City of Keene Planning Board

AGENDA

Monday, December 22, 2025

- d) **PB-2025-29 – 454 Elm St – Cottage Court CUP, Surface Water Protection CUP, & Major Site Plan** – Applicant Fieldstone Land Consultants PLLC, on behalf of owners Paul Chester & Gail Marie Dubriske, proposes to redevelop the property at 454 Elm St (TMP# 521-004-000) into a Cottage Court Development with 18 single-family dwellings. A surface water protection CUP is requested for ~1,435-sf of impact within the 30-foot wetland buffer. The parcel is ~2.3 ac in size and is in the Low-Density District.

Figure 2. A snippet from the proposed conditions plan showing the area of land to be transferred from the First Baptist Church to Cedarcrest.

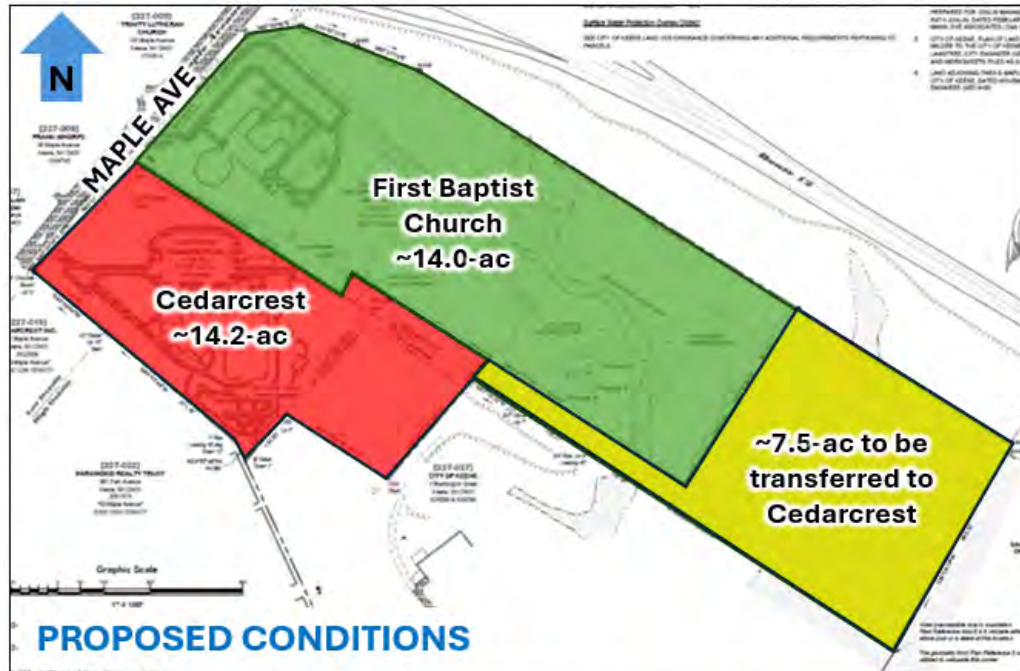
20.2.1 – LOTS: The proposed lot size and configuration for each parcel, shown in Figure 2 and Table 1, appear to meet all zoning and frontage requirements. This standard appears to be met.

Figure 2. A snippet from the subdivision plan showing the proposed location of Lots 1 & 2.

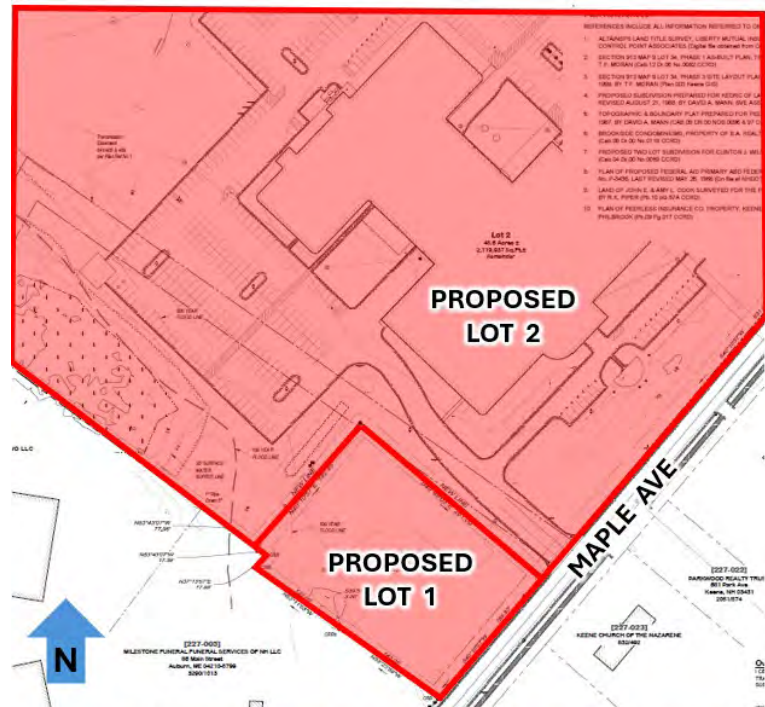
20.2.1 – LOTS: Proposed Lot 1 will be ~1.28-ac in size with ~189' of frontage along Maple Ave., and Lot 2 will be ~48.6-ac in size with ~631.9' of frontage along Maple Ave (Figure 2). If the zoning designation of the property is changed to Medium Density, the proposal will comply with all applicable zoning dimensional requirements for that district. Planning Staff will provide an update on the status of the map amendment at the December 22 Planning Board meeting.

LEVEL SPREADER 10 DT-3

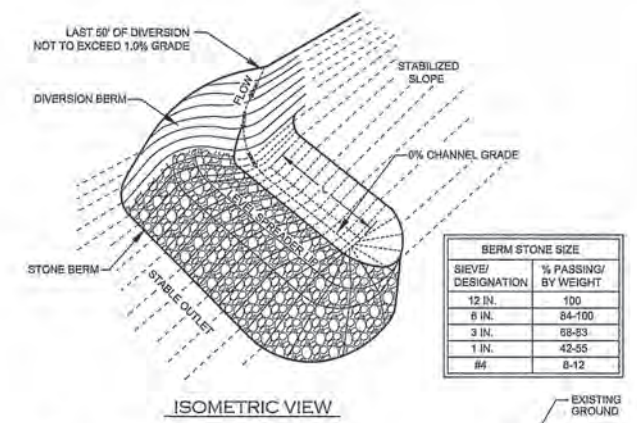
33. A level spreader is specified on the plans but no details are provided, please provide for clarity and construction. A level spreader detail has been included as detail 10 on sheet DT-3.

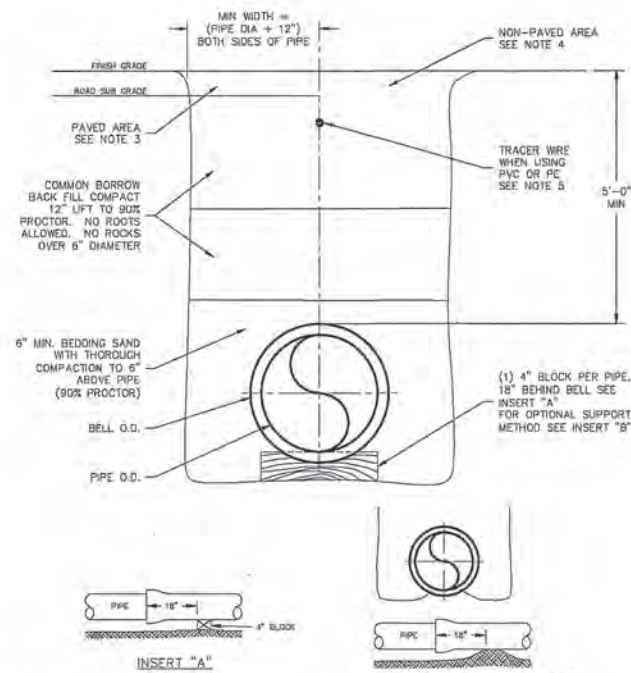
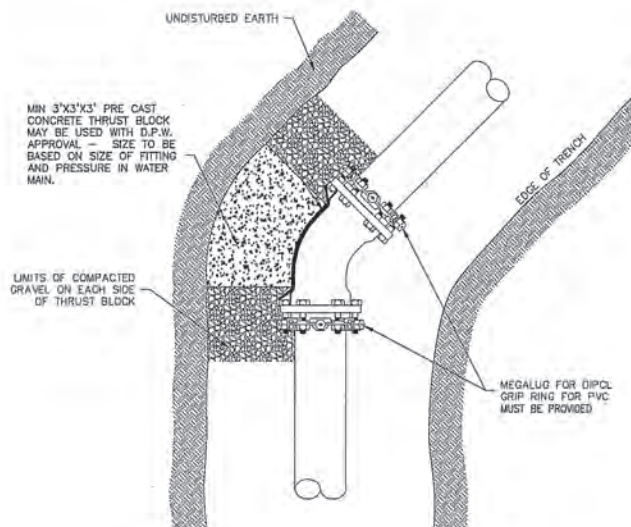
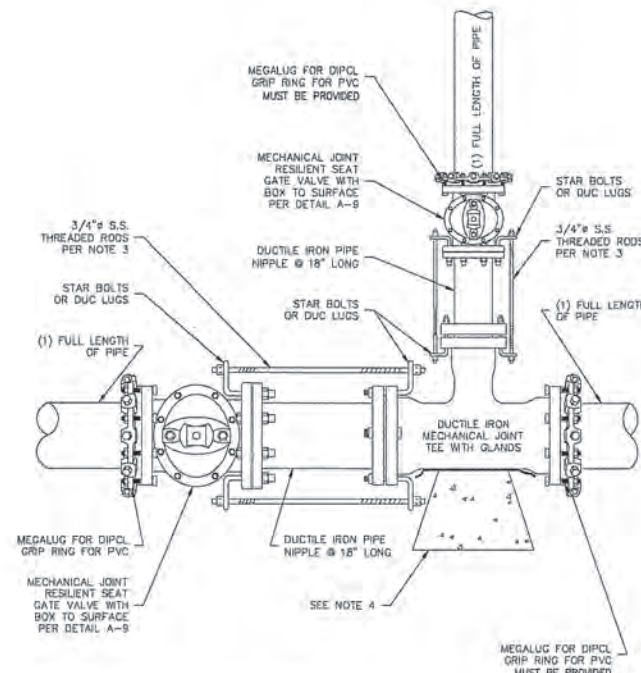
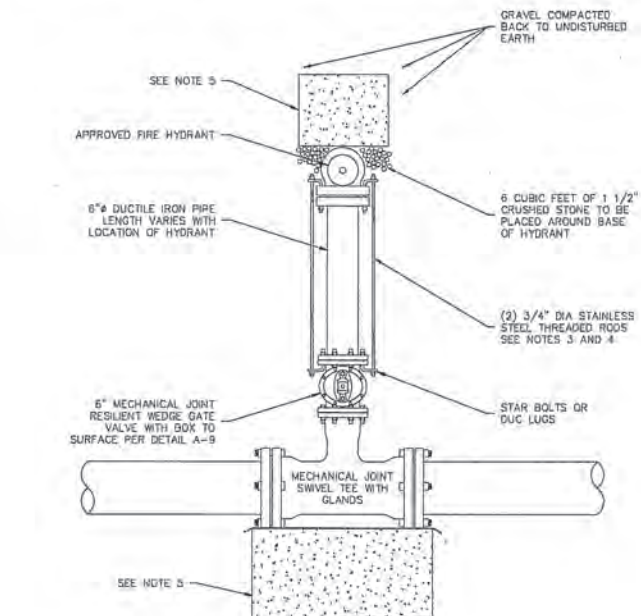
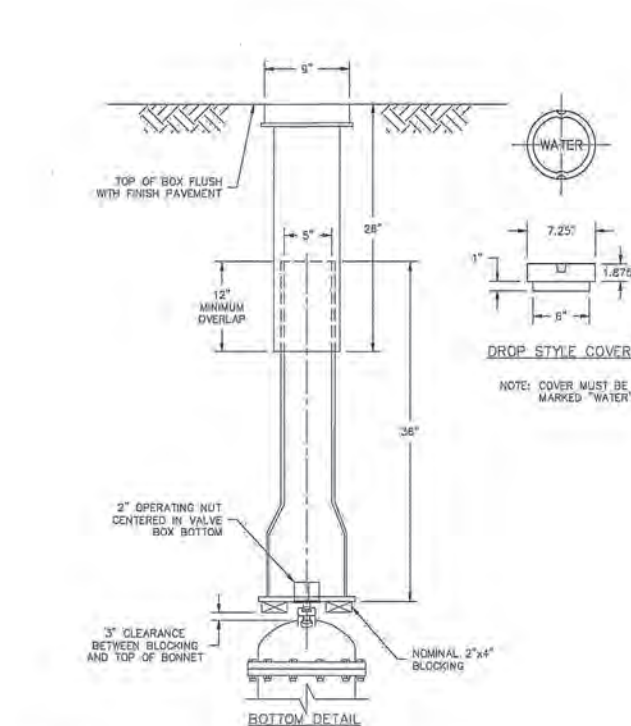
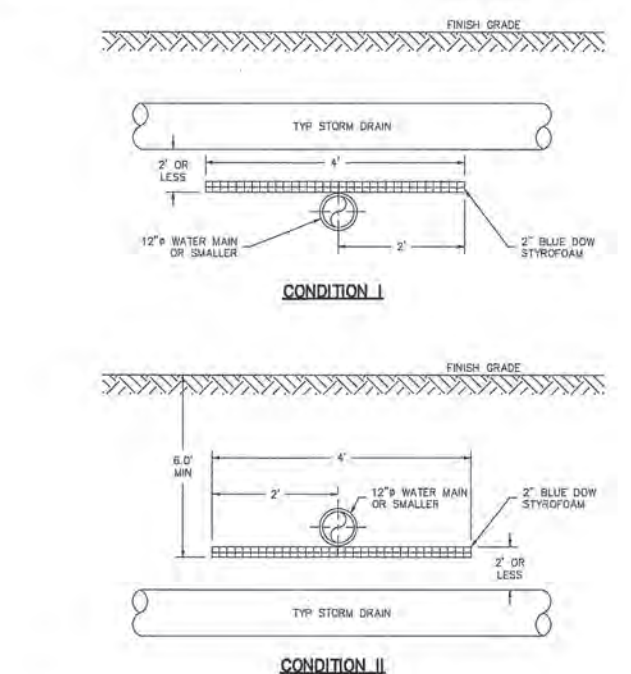
19. There are several references in the plan details to cast in place concrete thrust blocks; however, only precast thrust blocks will be accepted by the City. Please revise.
Details 2, 3, 4, and 7 on sheet DT-5 have been revised to proposed pre-cast thrust blocks
